42. BED HAMPTON HILL

Suggested illustrative revisions.
To be read in conjunction
with comments
dated 6/3/14

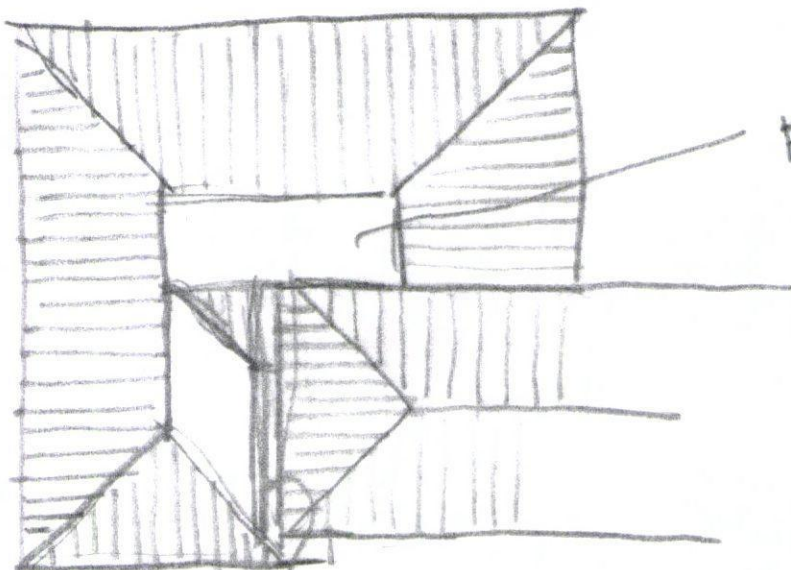
SHORT VALLEY
GUTTER

BATHROOM WINDOW

BRICK FACING TO MATCH
OR LARCH CLADDING.

DEEPER MORE
CONVINCING
ROOF

FLAT ROOF

SHORT VALLEY GUTTER
